service bulletin

No. 97-20

EFI and MPI Fuel Line Replacement

a - Fuel Line to TBI
b - Fuel Cooler.
c - Braided Fuel Line.

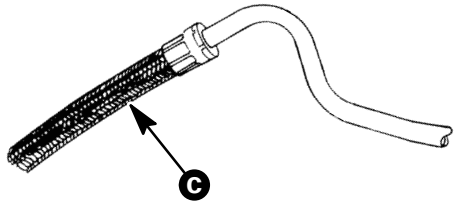
Look at the fuel cooler to TBI fuel line. If it is braided, the fuel line IS GOOD and does not have to be replaced.

a - Fuel Line to Fuel Rail.
b - Fuel Cooler.
c - 'Fire Sleeve' Pulled Back.
d - Brass Hose Coupler.
e - Stainless Steel.

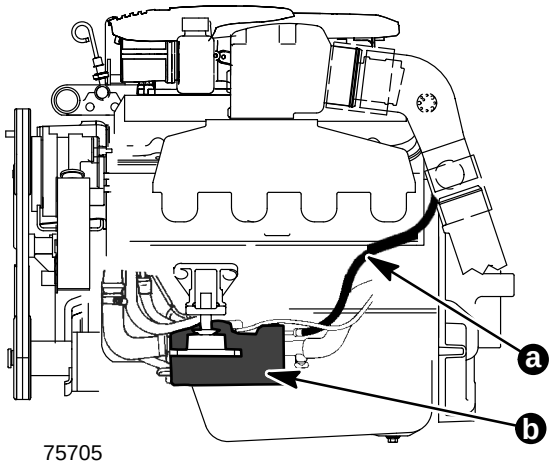
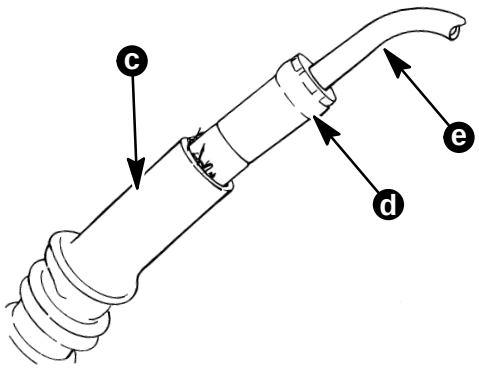
Look at the fuel cooler to fuel rail line. If the fuel line has a 'fire sleeve' AND the metal hose coupler is brass, the fuel line IS GOOD and does not have to be replaced.

a - Fuel Line to Fuel Rail.
b - Fuel Cooler.
c - 'Fire Sleeve' Pulled Back.
d - Brass Hose Coupler.
e - Stainless Steel.
f - Rail to Rail Fuel Lines.
g - Scorpion Intake Plenum.
h - 1997 350 Mag MPI Plenum. Not On 1998 350 Mag MPI Engines.

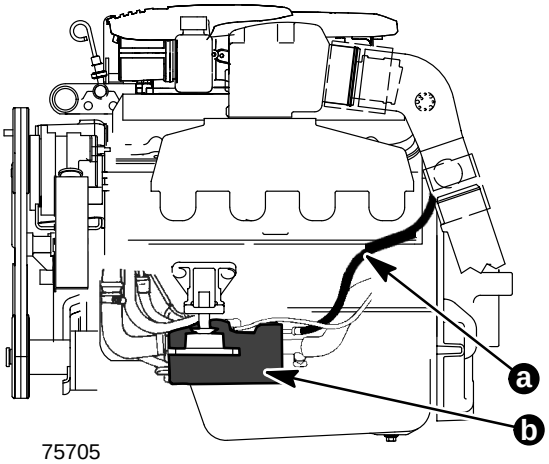
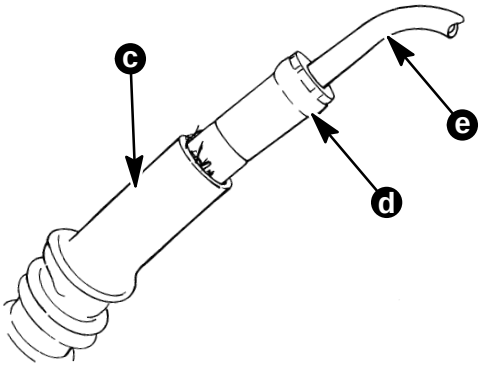
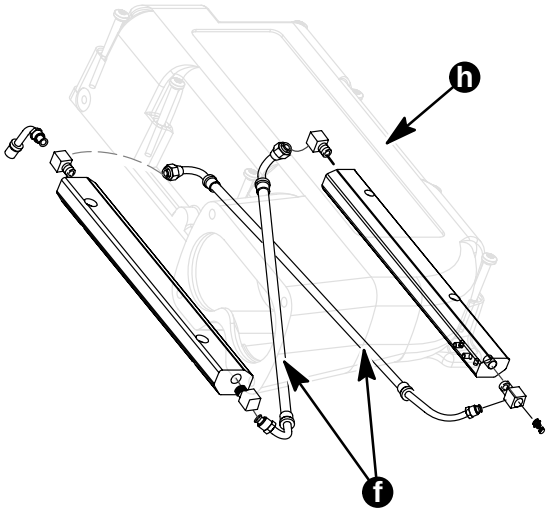
3. 1997 MCM 350 Mag MPI Sterndrive Engines:
   1997 MIE Black Scorpion MPI Ski, 377 Scorpion MPI Ski Engines:
   1998 MCM 350 Mag MPI Sterndrive Engines:
   1998 MIE 350 Mag MPI Ski Engines:
   1998 MIE 350 Mag MPI Inboard Engines:
   a. Look at the fuel cooler to fuel rail line. If the fuel line has a 'fire sleeve' AND the metal hose coupler is brass, the fuel line IS GOOD and does not have to be replaced.
   b. Also look at the 2 rail to rail fuel lines. If the fuel lines have a 'fire sleeve' AND the metal hose couplers are brass, the fuel lines ARE GOOD and do not have to be replaced.
